London Tramlink Modifications Panel

Proposal Information	Descriptions	
Submission Ref:	LT-Mods-13-008	
Document Title	Stadler Tram cab droplight window filming	
Date of Submission:	20/02/2013	
Submitted by:	Louis Wohlgemuth, London Tramlink	
Areas impacted by the change: <small>[Please tick all discipline areas or risk topics to ensure appropriate review of submission paper]</small>	TOL Operations	<input checked="" type="checkbox"/>
	3 rd Party works	<input type="checkbox"/>
	Track / Infrastructure	<input type="checkbox"/>
	Street Works	<input type="checkbox"/>
	Electrical Systems/OLE/signalling/DTO	<input type="checkbox"/>
	CDM applicable works	<input type="checkbox"/>
	Tram Technical Specification	<input checked="" type="checkbox"/>
	Depot Access	<input type="checkbox"/>
	Operational Procedures (including training / briefing)	<input checked="" type="checkbox"/>
Approval by MODs Chair	Name: 	Signature: 
	Date: 13.3.13

Proposal Information	Descriptions	
Submission Ref:	LT-Mods-13-042	
Document Title	Stadler Tram cab window filming – sash and quarterlights	
Date of Submission:	02/07/2013	
Submitted by:	Louis Wohlgenuth, London Tramlink	
Areas impacted by the change: <small>[Please

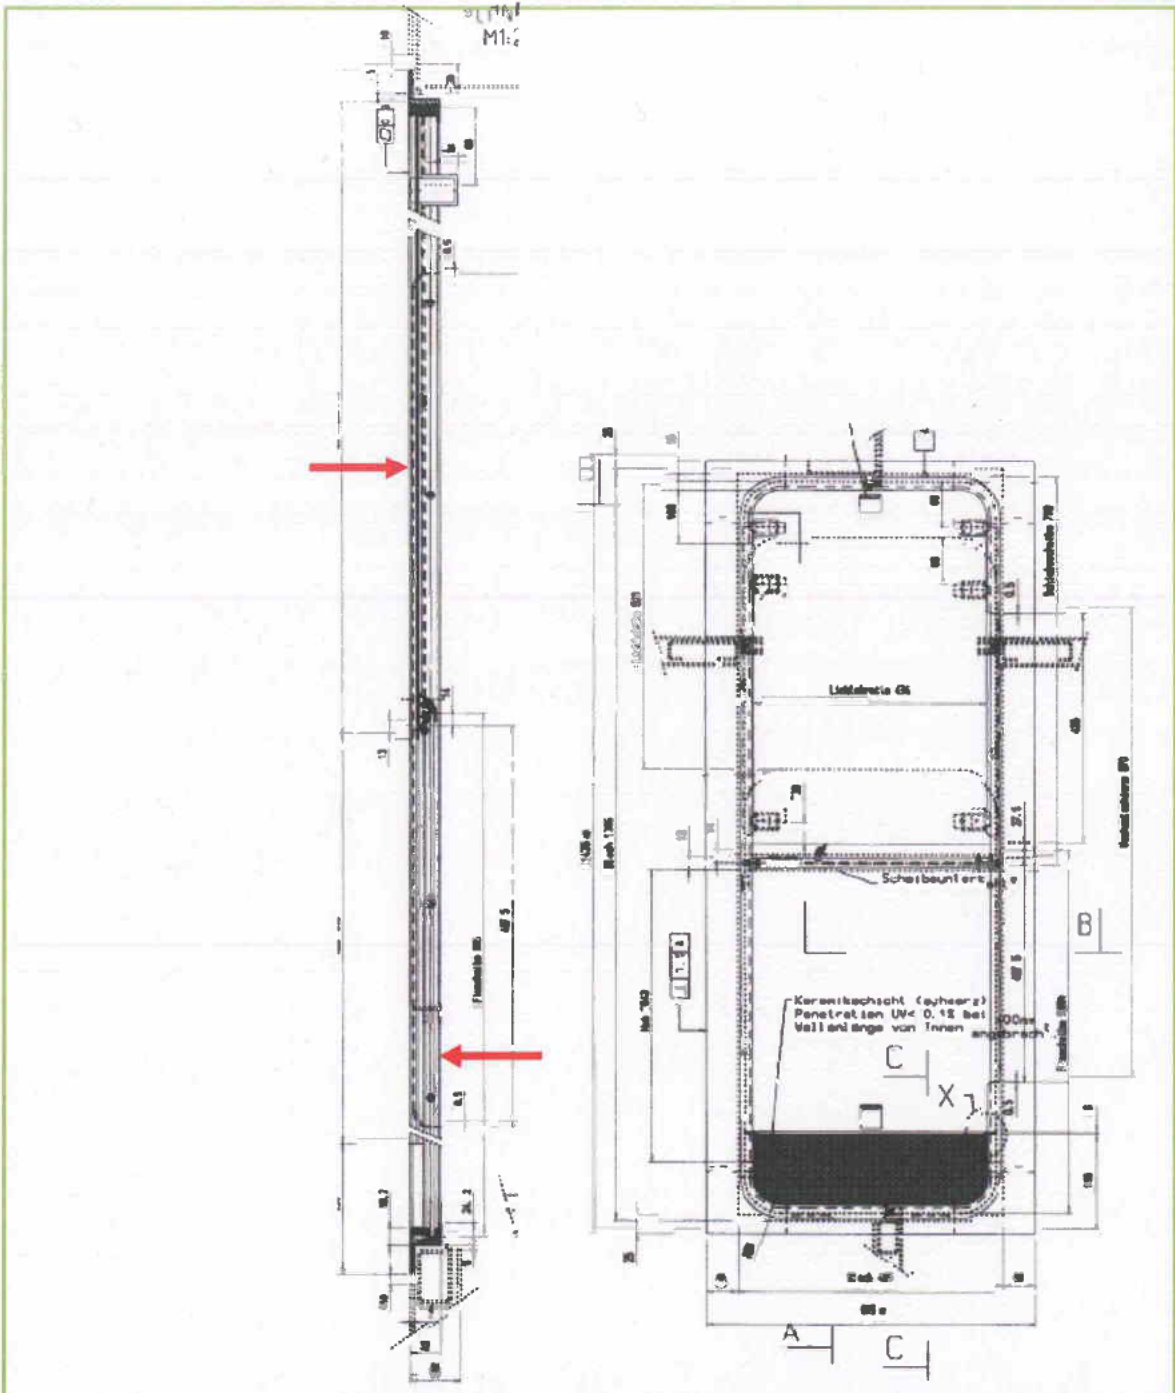
It is proposed that film is applied to the sash (droplight) window in order to prevent the glass shattering in the unlikely event that a second impact is received before the glass is changed out.

It is proposed that the first installation is tried in 1 out of the SVT cabs to ensure that:

Criterion c) will be measured empirically using an IsoTech Lux 1335 Digital Light Meter. The SolarGard Amorcoat 4 Mil Clear film has a transmissivity of 89%. The Stadler supplier drawing (Euromotive 1-00231R01 issue 1) states the following:
